## **2013 Asphalt Paving of Streets Addendum #2**

**Date: March 19, 2013**

**Re: Changes to Bid Proposal Quantities (Revised Bid Proposal Form); Revision of Engineer's Estimate for Alternate #1; Revised Attachment B; Correction to Technical Specifications (Removals, Excavation, and Embankment-Alternate #1); Correction to Technical Specifications (Special Items-Alternate #1)**

**2013 Asphalt Paving of Streets**  
**Alternate #1 - Market St. Parking Lot**  
 Michael L. Heintz, P.E., P.S.  
 CITY ENGINEER

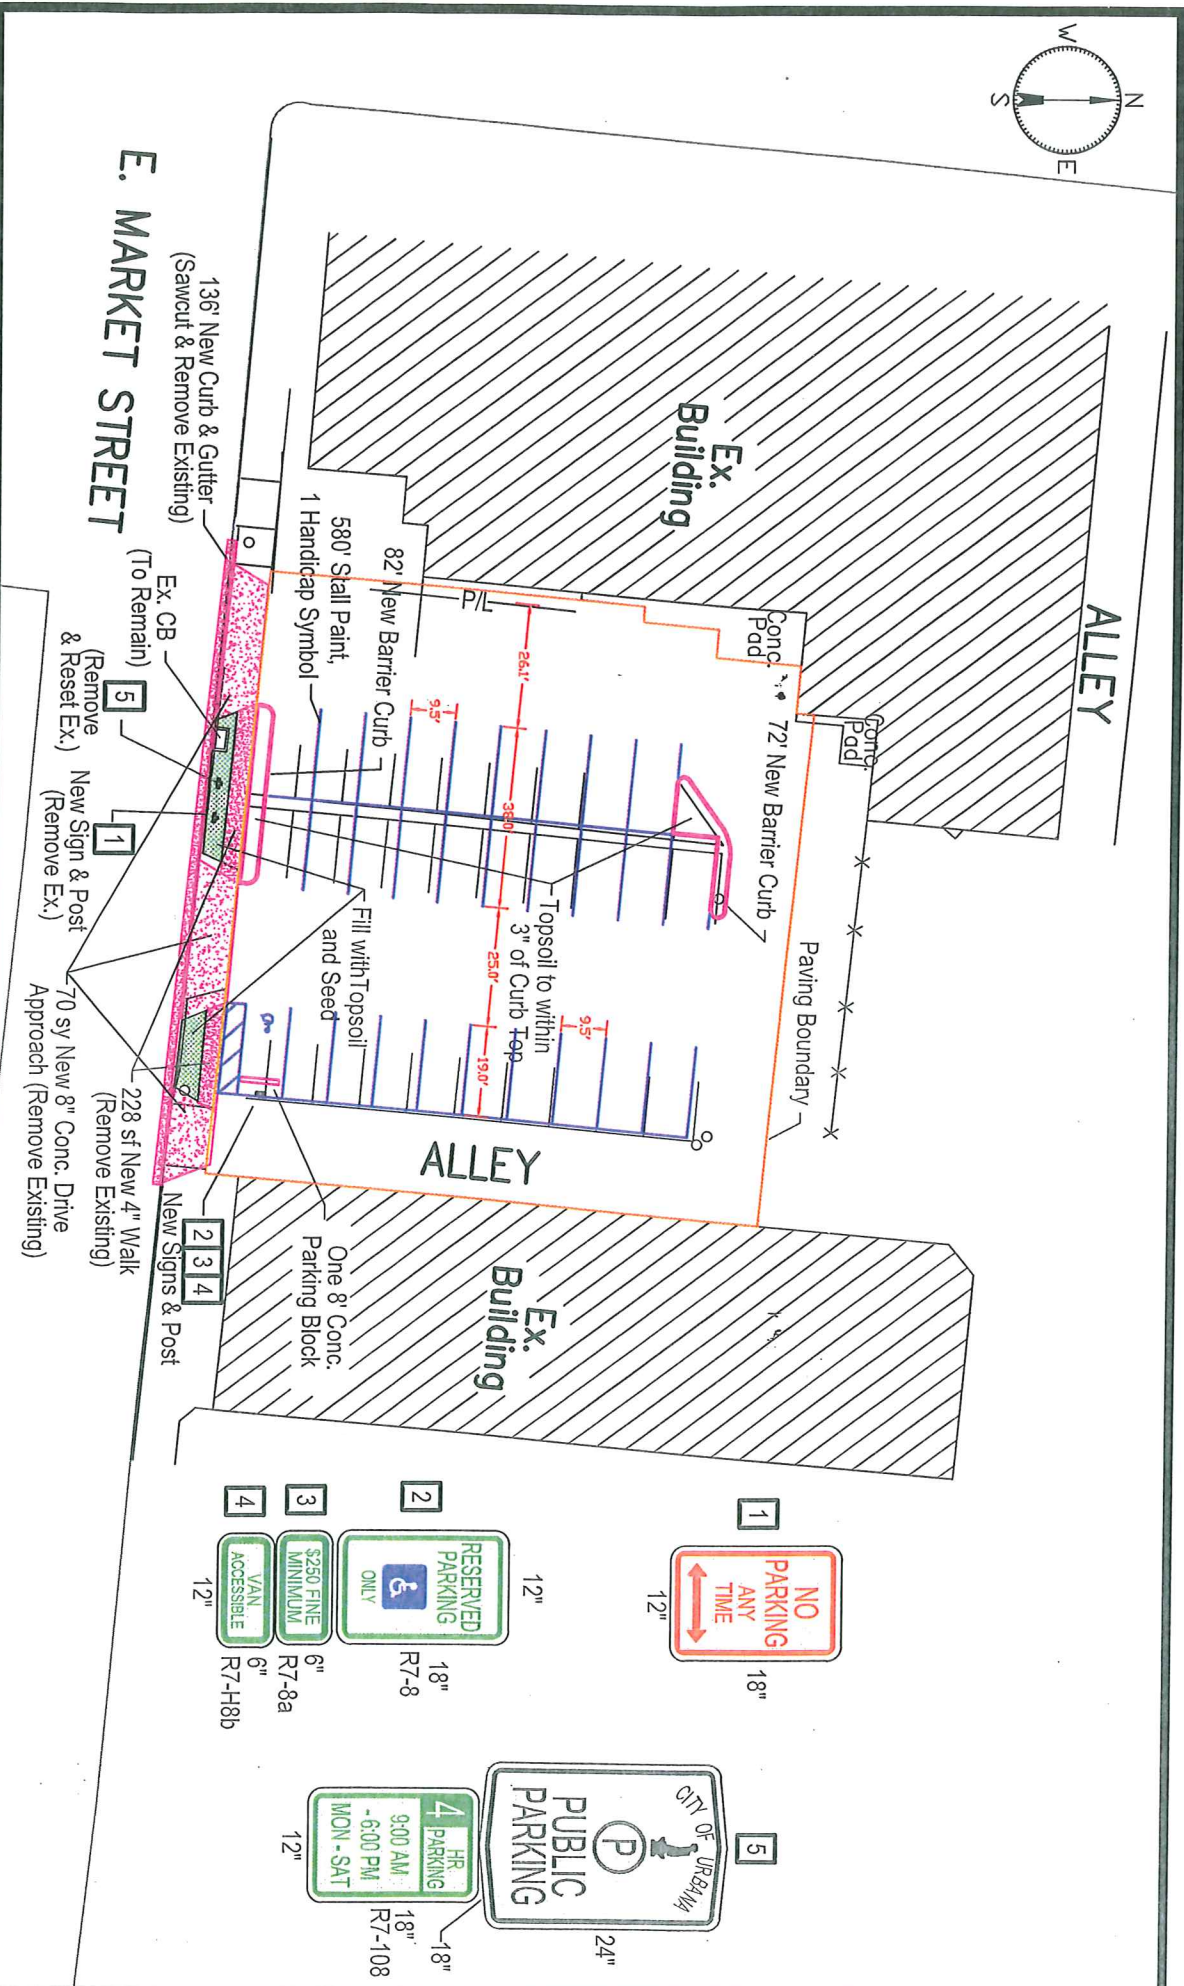
The revised Attachment B (dated 3/18/2013) included with this addendum shall supersede and replace the previous version of this document.

Under the Technical Specifications (Section III), the section titled "Removals, Excavation, and Embankment-Alternate #1" on page 47 shall be retitled to read "Excavation and Embankment". The first paragraph of this section about removals shall be deleted. The removal of the specified wall and fence shall be deleted from the project.
